ADDENDUM NO.	1	DATED	8/17/2015	ADDENDUM NO.		DATED	
ADDENDUM NO		DATED		ADDENDUM NO.		DATED

Number	Description
1	Revised Table of Contents; Add NTB Nos. 5786 & 5787; SP 907-622-7, replaces SP 907-622-6; Revised BidItems; Revised or Added Plan Sht. Nos. 2, 4-11, 13-16, 22-25, 27-31, 33, 34, 38, 46-49, 85, 86, 88, 93-95, 212, 213, 220-223, 249-251, 256-259, 262, 263, 319, 320, 331-333, 2001, 2031, 6315, 6316, & 6324; Amendment EBS Download Required.

PROJECT: STP-0056-01(075) / 104101301 - Rankin

Construction necessary to Add 2 Lanes to SR 25 from SR 475 to Grants Ferry Road, known as Federal Aid Project No. STP-0056-01(075) / 104101301 in Rankin County.

Wk. Sh. 13LT
Sh. No. 85

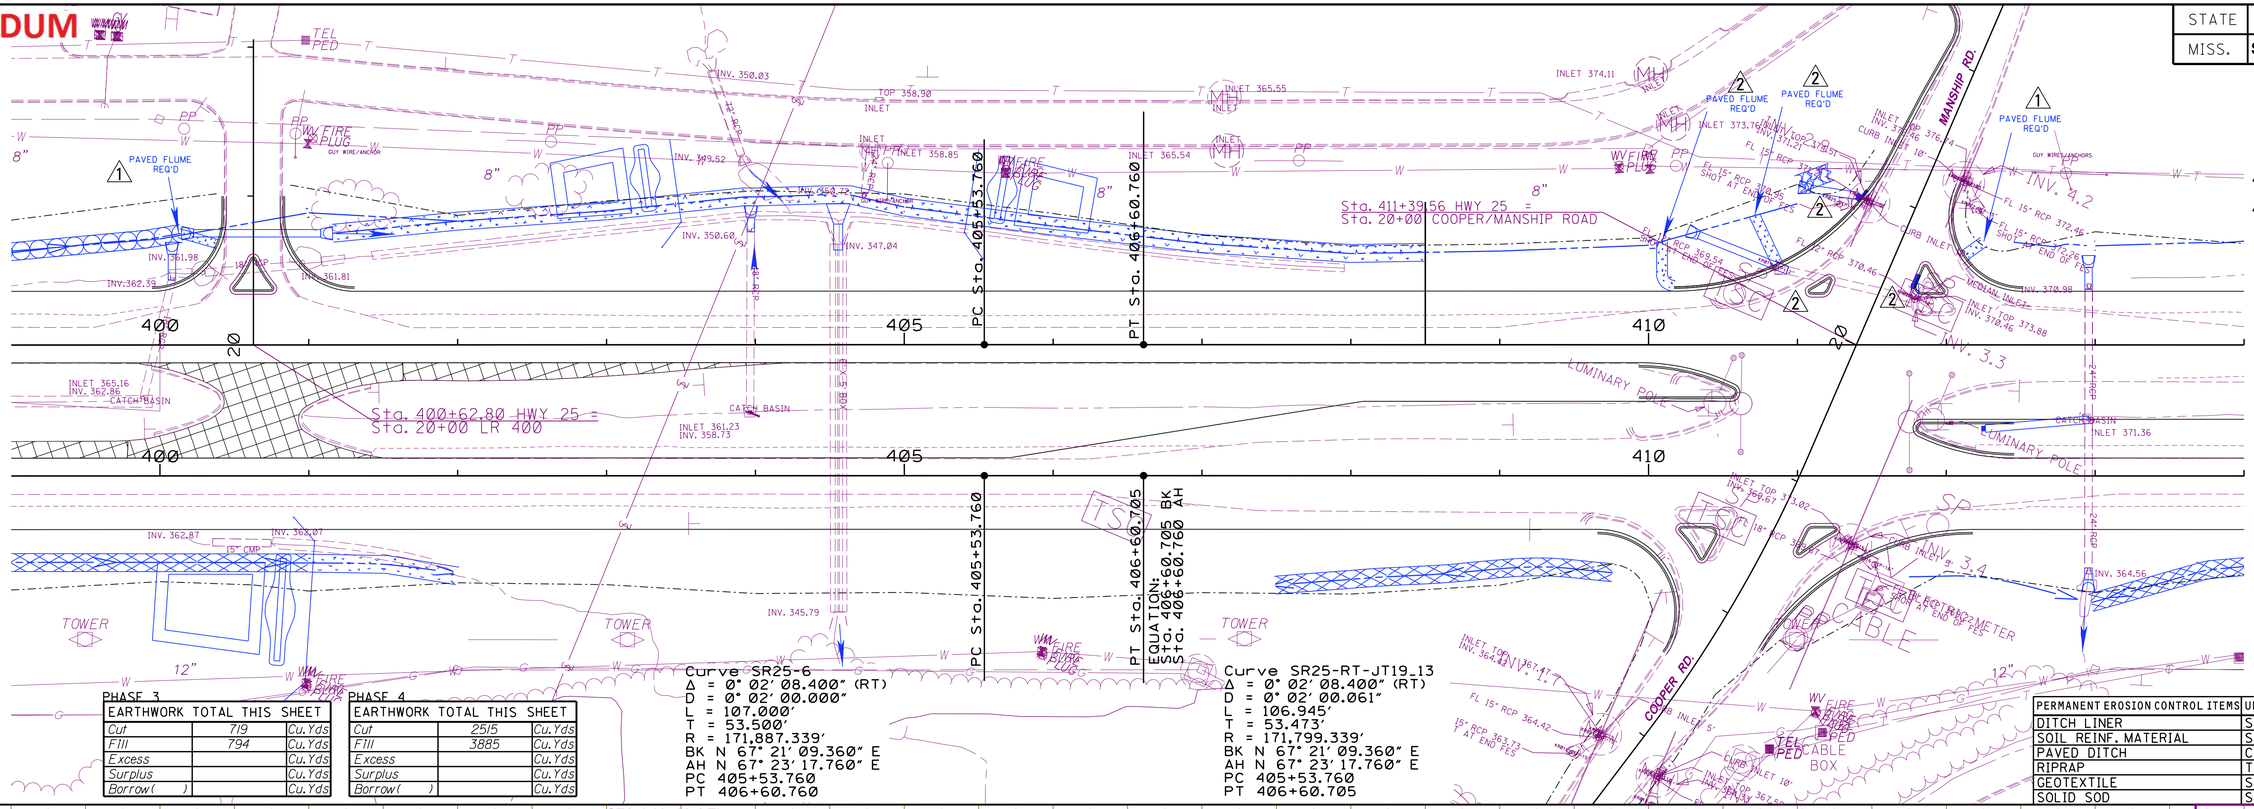
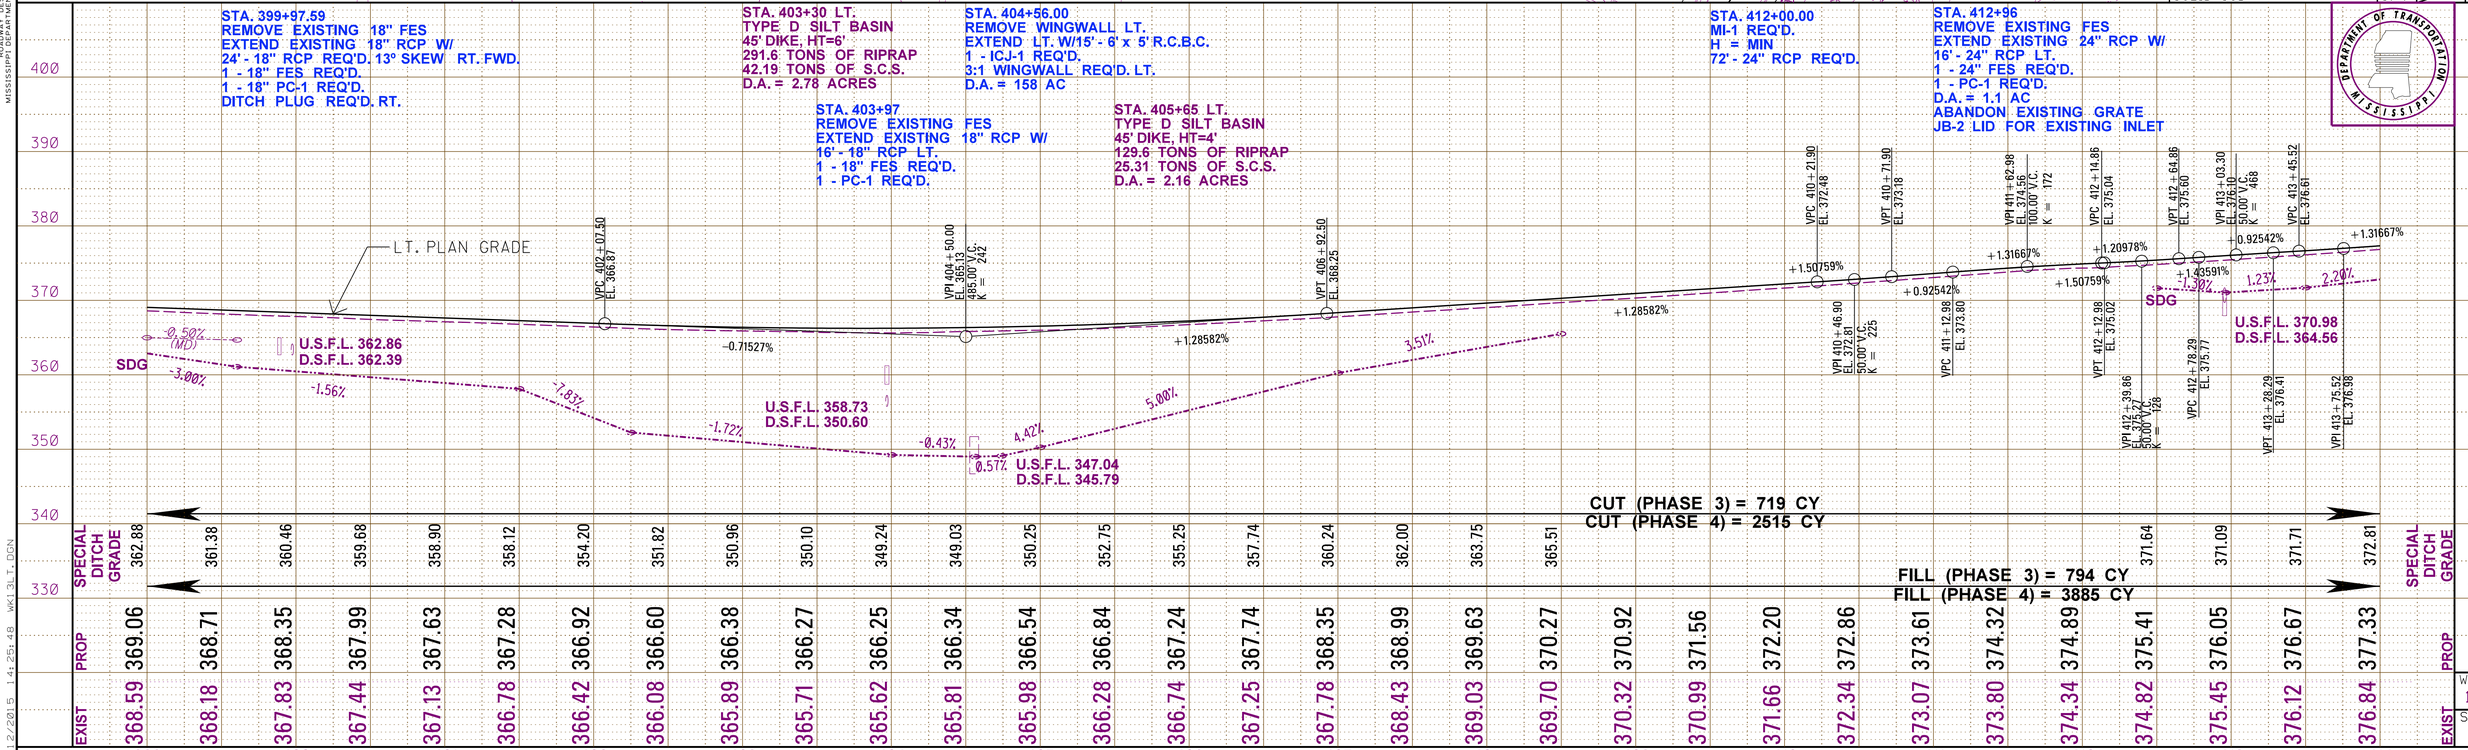
REVISIONS		
	DATE	BY
1	7/20/15	JT
2	8/12/15	JT

1 ADDED PAVED FLUMES
2 REVISED DRAINAGE

STA. 412+96
REMOVE EXISTING FES
EXTEND EXISTING 24" RCP W/
16' - 24" RCP LT.
1 - 24" FES REQ'D.
1 - PC-1 REQ'D.
D.A. = 1.1 AC
ABANDON EXISTING GRATE
JB-2 LID FOR EXISTING INLET

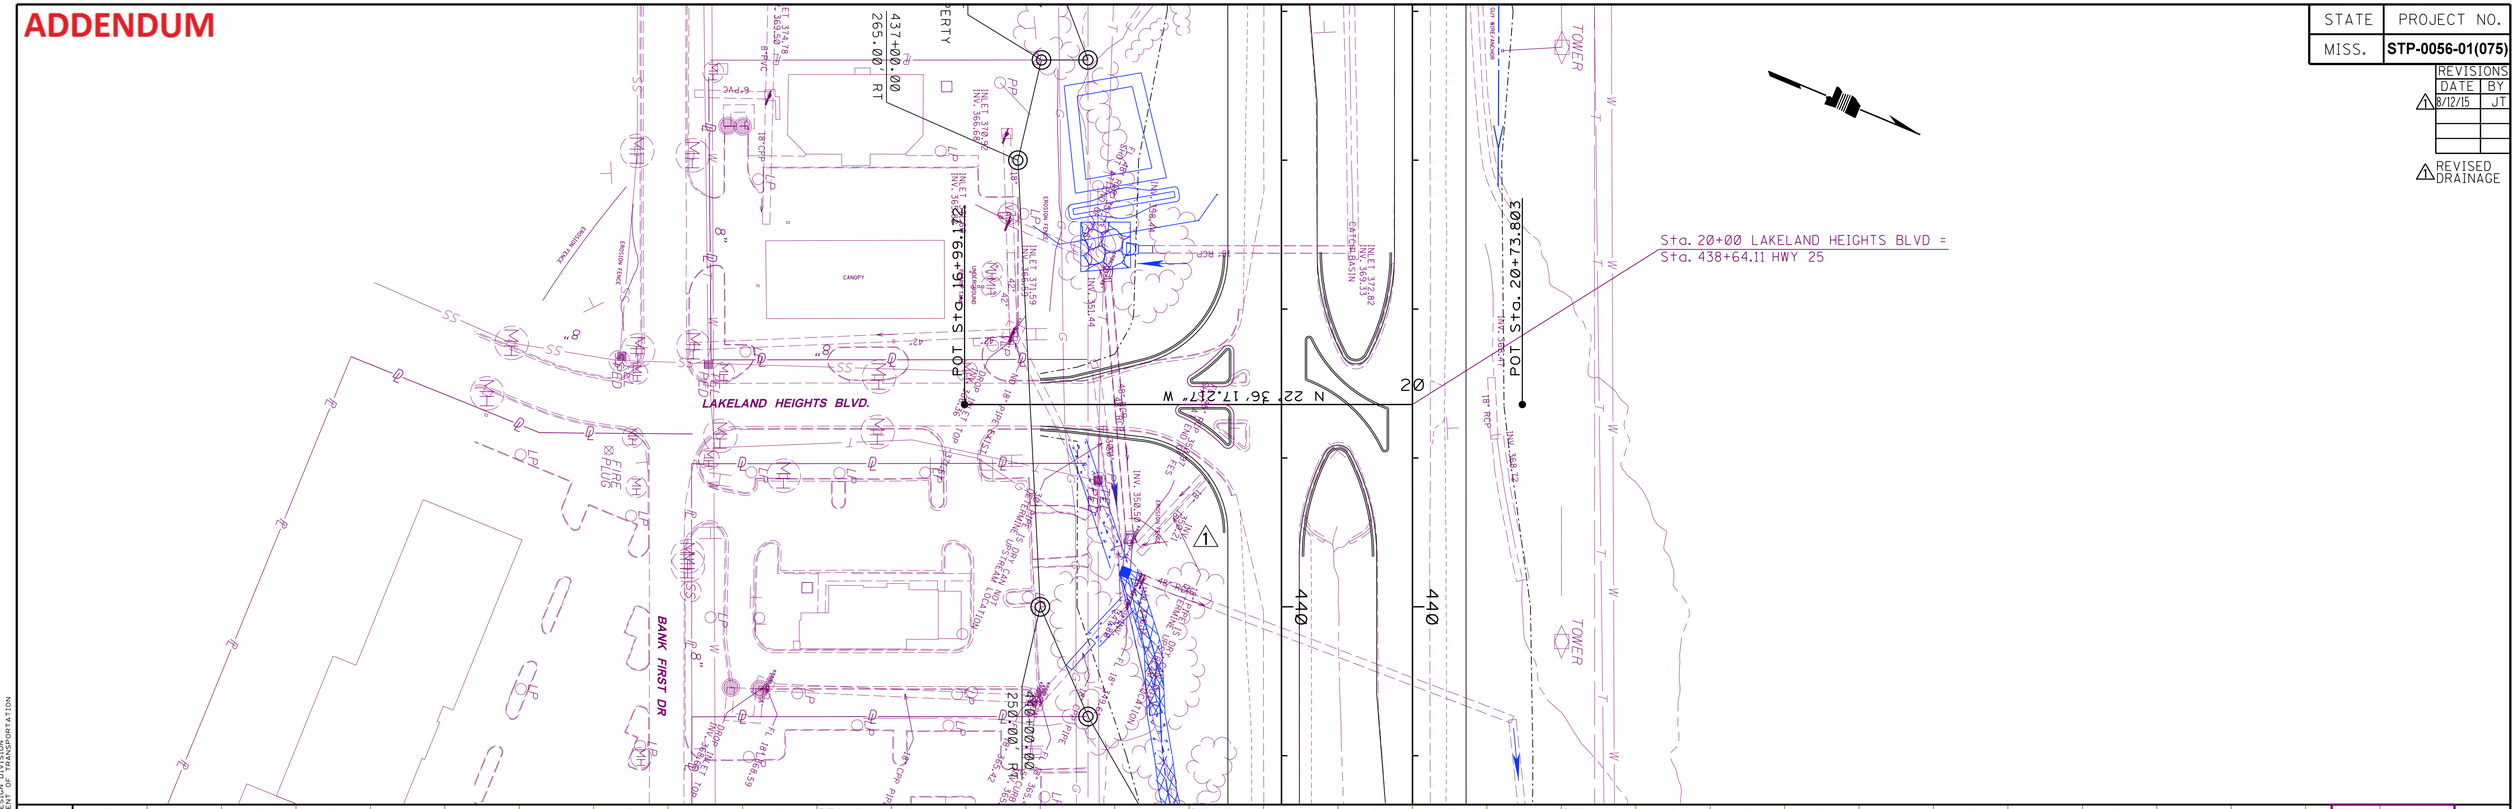
1 STA. 17+55.72
121' (+/-) 30" EXISTING CPP
(IN PLACE) NOT IN USE
REMOVE PIPE BACK TO NATURAL GROUND
FILL AND ABANDON REMAINING PIPE
8' ESTIMATED

1 STA. 18+02.62
REMOVE EXISTING FES
EXTEND EXISTING 48" RCP W/
24' - 48" RCP TO MODIFIED JB-2
SKEWED 10° RT. FWD. FROM EXISTING
ENTERING MODIFIED JB-2 @ 15° LT. FWD.
1 - PC-1 REQ'D.

1 STA. 18+17.66
67' (+/-) 18" EXISTING CPP
(IN PLACE) NOT IN USE
REMOVE PIPE BACK TO NATURAL GROUND
FILL AND ABANDON REMAINING PIPE
8' ESTIMATED

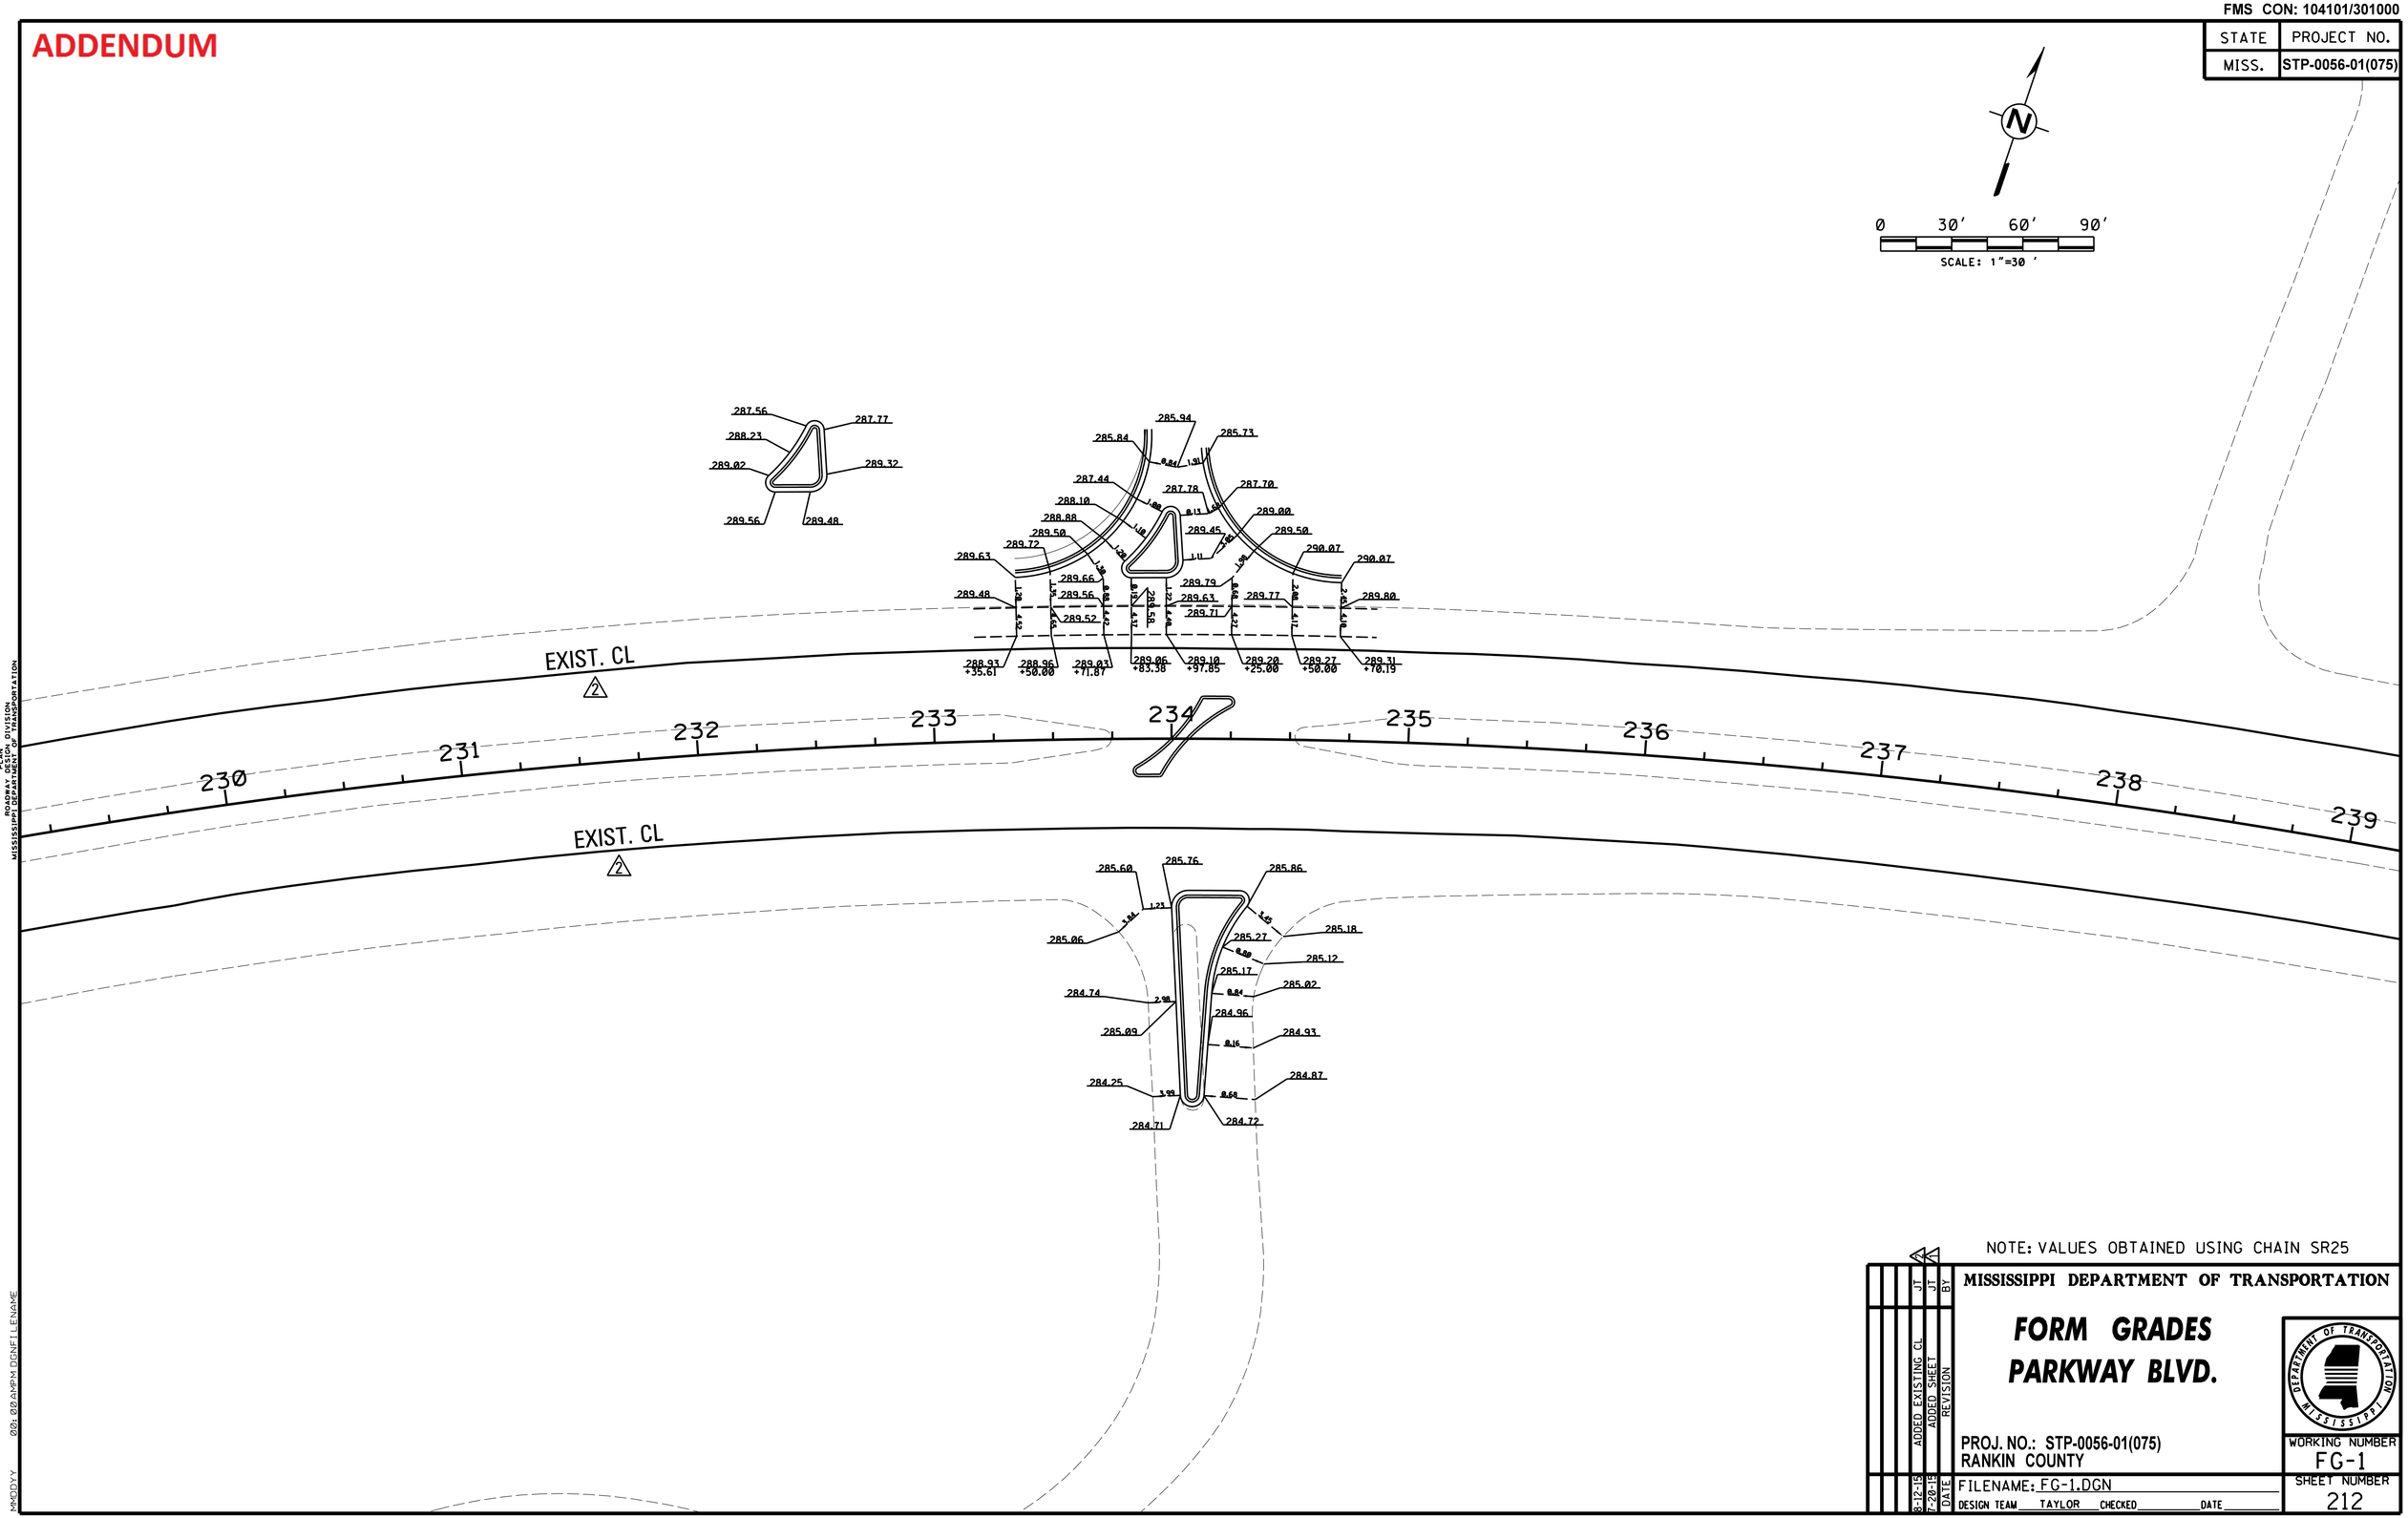
BY	DATE	REVISION
JT	8-12-15	ADDED EXISTING CL
JT	7-20-15	ADDED SHEET
